Title of Change:	TOLL packages alternative option ATX WEIHAI, China (ATXWH).
Effective date:	15 Feb 2024
Contact information:	Contact your local onsemi Sales Office or Daryl.Cruz@onsemi.com
Type of notification:	This Product Bulletin is for notification purposes only. onsemi will proceed with implementation of this change upon publication of this Product Bulletin.
Change Category:	Test Change, Assembly Change
Change Sub-Category(s):	Manufacturing Site Addition

This Product Bulletin is the follow up of IPCN24870Z announcing ATX WEIHAI, China (ATXWH) has been qualified as an additional Assembly and Test Operations manufacturing site of H-PSOF8L (TOLL) packages as listed below.

H-PSOF8L 9.90x10.38x2.30
CASE 100BQ
ISSUE O

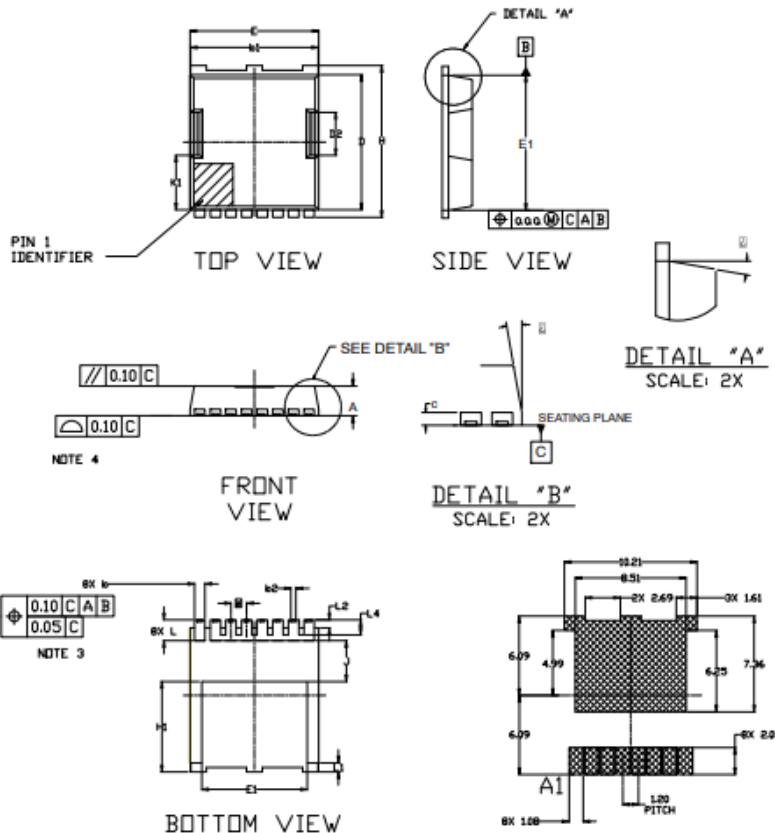
TOLL products processed at ATXWH will use ATXWH Bill of Material as shown below and can be ordered using the new part numbers. Parts processed at onsemi Cebu, Philippines can continue to be ordered under the existing OPN.

The BOM for each assembly site is shown below.

Current BOM	Additional BOM
Assembly	onsemi Cebu, Philippines	ATX Weihai, China
Lead frame	LF NA PackTypeL CKFC STAMPED	TOLL T-post Ni/NiP Plating
Adhesion Promoter	DA PRMTR AP8000	DA PRMTR AP8000
Die attach solder	95.5Pb2Sn2.5Ag	95.5Pb2Sn2.5Ag
Bonding wire	Aluminium wire 5mil & 20mil	Aluminium wire 5mil & 20mil
Mold Compound	CEL-9240HF 10LS	EME-G700LH
Case outline #	100CU	100BQ
Final Test	onsemi Cebu, Philippines	ATX Weihai, China
